Technical Information

To : ICOM Distributors
From : ICOM Inc. / Export Department
Ref No. : SEN-014-03
Date : December 16, 2003

Re. Improvement of the PA Driver for the IC-703.

Parts Location on the MAIN board. (W998)

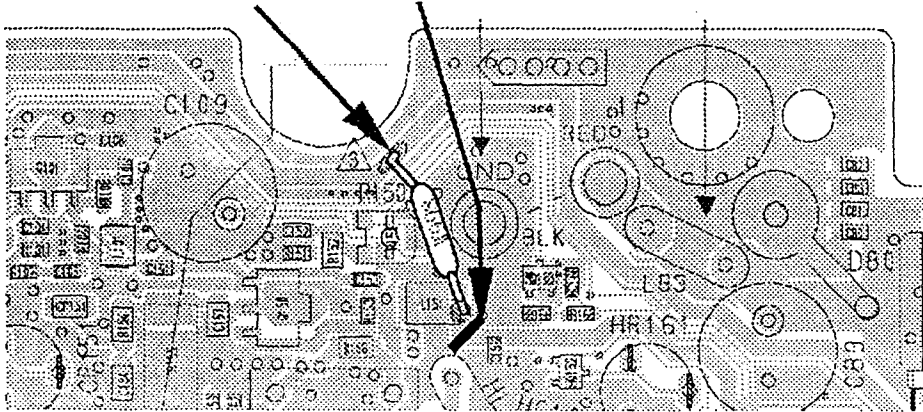
The driver transistor (RD01MUS1) on the PA stage will be damaged when the transceiver is used in a high temperature environment.

For solution of this problem, we have reduced the current drain of the circuitry on the PA stage.

Solder the W998. Cut the PC trace on the MAIN board.

Board	Parts Number	Parts Number (Old)	QTY	Parts Number(New)	QTY	Action Taken
PA	W998			7120000470	1	Added
		None		ERDS2TO
